Office Action Summary	Application No. 10/511,695	Applicant(s) HERCZEG, ATTILA	
	Examiner Krishnan S. Menon	Art Unit 1797

DETAILED ACTION

Claims 2,4,6,7 and 10-12 are pending as amended in the RCE of 8/20/08; claim 12 is independent.

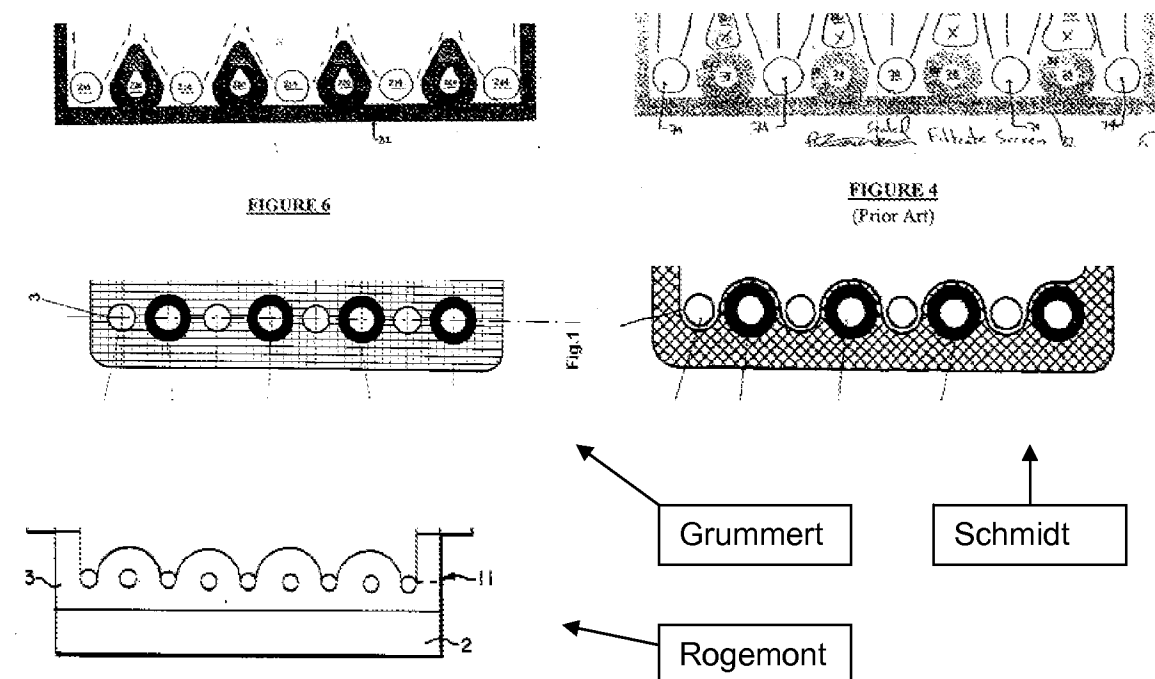
(2) The newly added limitation to claim 12, copied below, is unclear. How can the feed and retentate apertures define the filtrate channels? The recitation of the “uniform flow ... of apertures seals” is also unclear. For examination purpose, it is assumed that the sealing resin is spread into the filtrate channels, defining some specific shape for the filtrate channels around those apertures.

Pictures from applicant's disclosure, disclosed prior art, Grummert, Schmidt and Rogemont (in that order, from left to right) showing the permeate screen. All of them

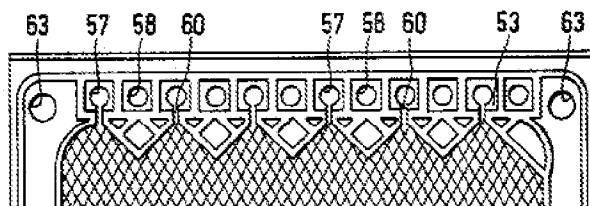
show the resin layer around the feed/retentate hole penetrating the screen material.

They do not appear to form any non-uniformities in fluid flow therethrough. Particularly, compare the similarity of applicant's figure 13 to that of Rogemont. The resin layer is taught as penetrating across the screen layer in all the cited references.
